# Ventura County Community College District

DATE: July 18, 2025  
TO: All Bidders  
FROM: Spencer Herson, Purchasing Specialist  
SUBJECT: Addendum 1 – Bid 717, Ventura College STEM Program Building Re-Bid

**DRAWING** changes and clarifications noted as Addendum 02 and dated 07/18/2025:

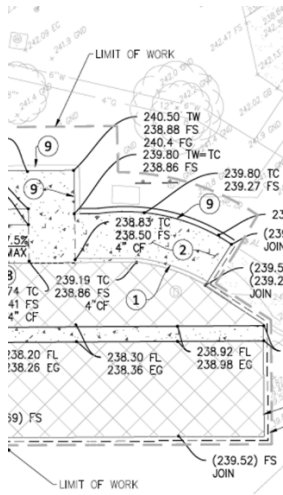
9. Sheet L3.1 Detail 4/L3.1 - It calls for a root barrier (per specs), but I do not see the specs called out. Please provide.

- A. Material – Root barrier shall be Century products 24 inch high, .085 thick HDPE. Or equal.
- B. Installation – Install tree root barrier in the total lengths as shown on the plans and detail. The vertical deflecting ribs shall be facing inward to the root ball and shall be set 1 inch above finish grade. Panels shall be connected with the flexible joiner strips to the required overall length as per the plans. Install panels straight, uniform in a vertical position.
